**ANN ARBOR HISTORIC DISTRICT COMMISSION**

**Staff Report**

**ADDRESS:** 112 W Liberty Street, Application Number HDC21-297

**APPLICATION:** The applicant seeks HDC approval to install five banners that span the alley as part of a one-year public art installation.

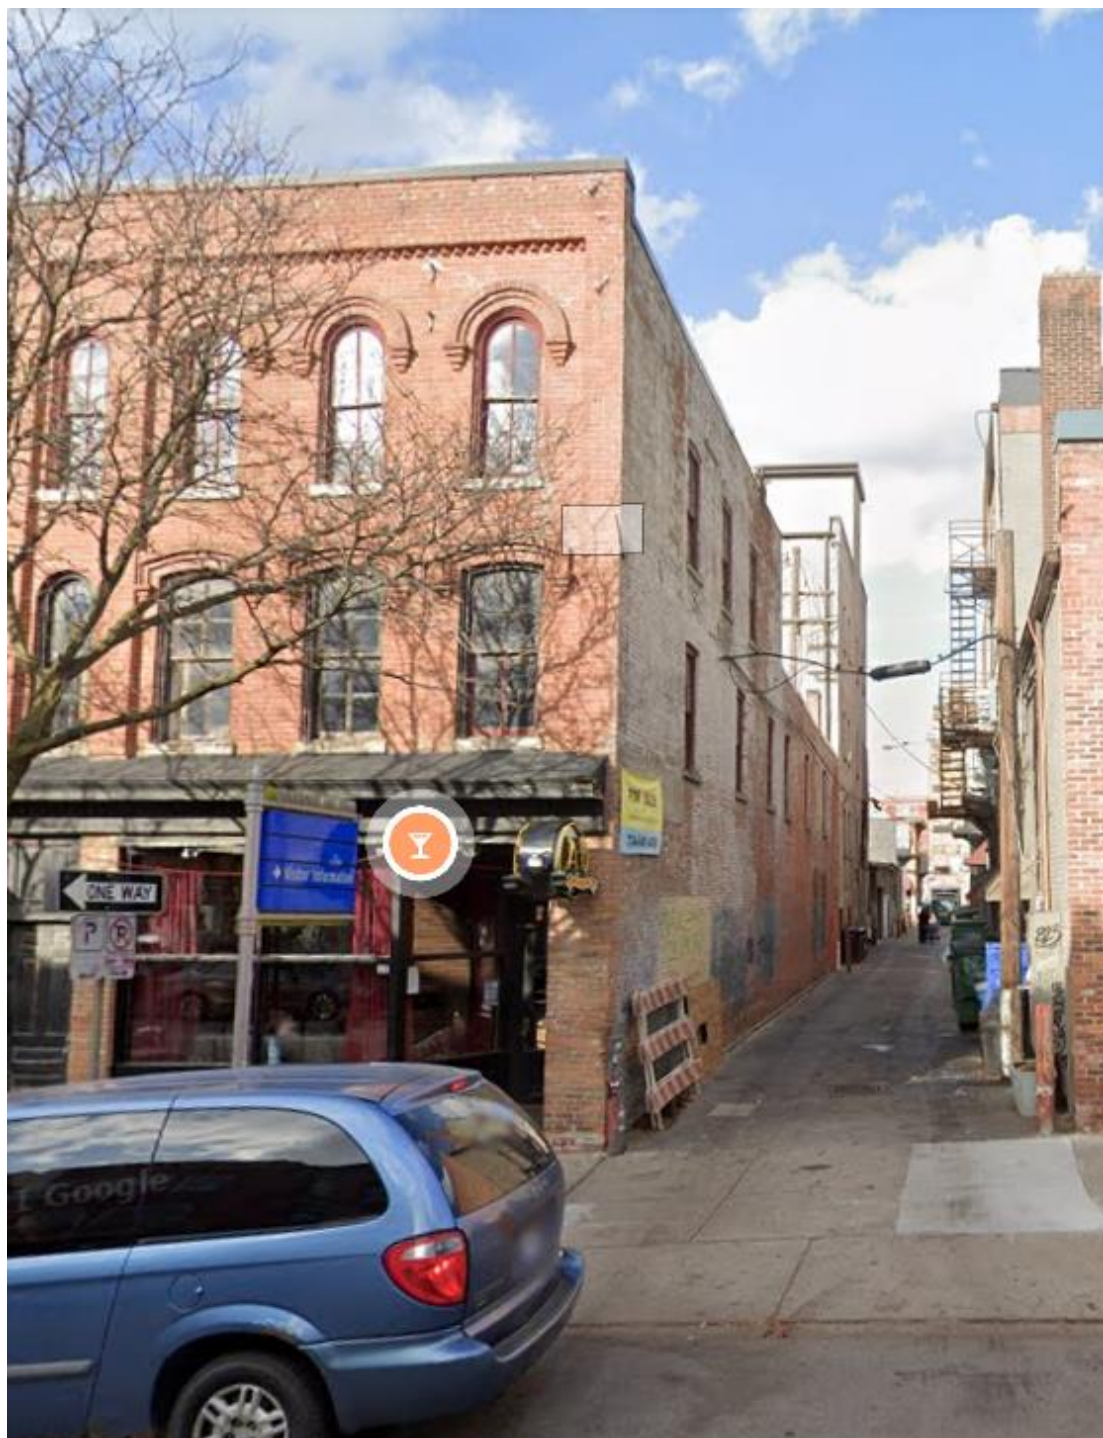
1. This application is for a public art installation on the east wall of 112 West Liberty and on the floor in the adjoining alley. The wall installation consists of approximately 85 two-foot-long painted aluminum bars affixed to the wall with an integrated bracket mounted with two anchors. Each bar weighs 1 lb 6 oz. The brick wall behind the bars would be painted. On the alley floor, the pavement and part of the sidewalk would be painted and foil-based decals applied to the pavement. Signatures were provided from the 112 West Liberty property owner and the City of Ann Arbor, which owns the alley.

2. This wall was damaged by a previous mural installation that drilled through bricks and mortar joints to mount six large panels. It has not been repaired since the mural was removed. There are numerous holes in both the bricks and the mortar, and a number of bricks in the project area are in poor condition. The lower of the two windows closest to West Liberty has a broken pane of glass that needs to be replaced.

3. The area of paint is specified on the drawings. This wall has paint on it, but it is not even or consistent and much of it appears to be in response to graffiti. The Historic District Commission will need to determine whether it is appropriate to paint the brick wall. It would not be appropriate to paint over the sills or the window glazing. If painting the masonry units is allowed, the wall should at a minimum be repointed before being painted so the paint doesn't hide existing problems.

4. This alley is notorious for wall damage (visible in photos) caused by turning trucks. The colorful bars must be installed in such a way that if pulled off the wall by trucks or other vehicles, the anchors will not harm the brick.

Proposing to drill through brick is not preserving masonry and not appropriate. If the mortar joints are too small, uneven, or otherwise unsuitable for this proposed project, or if the edges of bricks are endangered by the work, the project should not be installed.

6. Staff believes the work is inappropriate based on the proposed method of installing the steel brackets and should be denied. The Masonry Notes are clear that installing anchors in the masonry joints would likely damage the bricks; therefore, staff has not conditioned the motion on installation only in masonry joints.
